Project	IEEE 802.16 Broadband Wireless Access Working Group < http://ieee802.org/16 >	
Title	Figure F7 Changes	
Date Submitted	2007-01-4518	
Source(s)	Peretz Feder - ALU	pfeder@alcatel-lucent.com ,
	Honghai Zhang – ALU	hozhang@alcatel-lucent.com
	Philp Barber - Huawei	pbarber@huawei.com
Re:		
Abstract	Changes to Figure F7	
Purpose	Adoption	
Notice	This document has been prepared to assist IEEE 802.16. It is offered as a basis for discussion and is not binding on the contributing individual(s) or organization(s). The material in this document is subject to change in form and content after further study. The contributor(s) reserve(s) the right to add, amend or withdraw material contained herein.	
Release	The contributor grants a free, irrevocable license to the IEEE to incorporate material contained in this contribution, and any modifications thereof, in the creation of an IEEE Standards publication; to copyright in the IEEE's name any IEEE Standards publication even though it may include portions of this contribution; and at the IEEE's sole discretion to permit others to reproduce in whole or in part the resulting IEEE Standards publication. The contributor also acknowledges and acc

Figure F7a – MS Initiated HO: End-to-End HO exchange between MS, Serving BS and Target BS

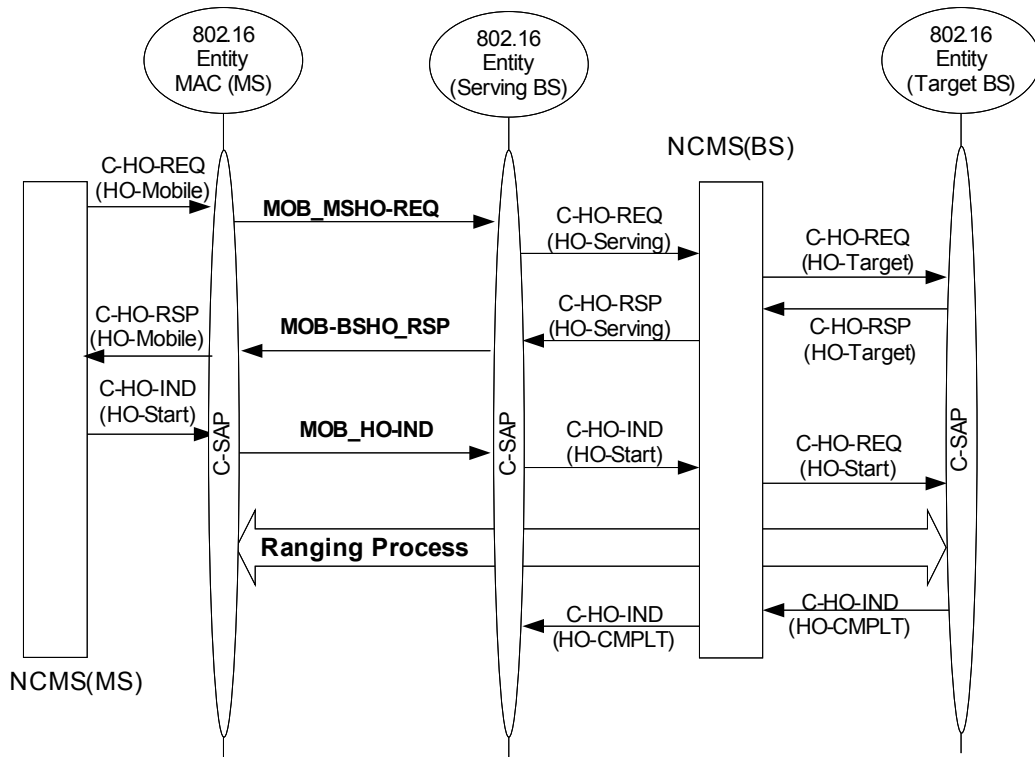
8 Update to Figure F7 adding mobile initiated with C-HO-REQ (HO-Mobile) and C-
9 HO-RSP (HO-Mobile) primitives
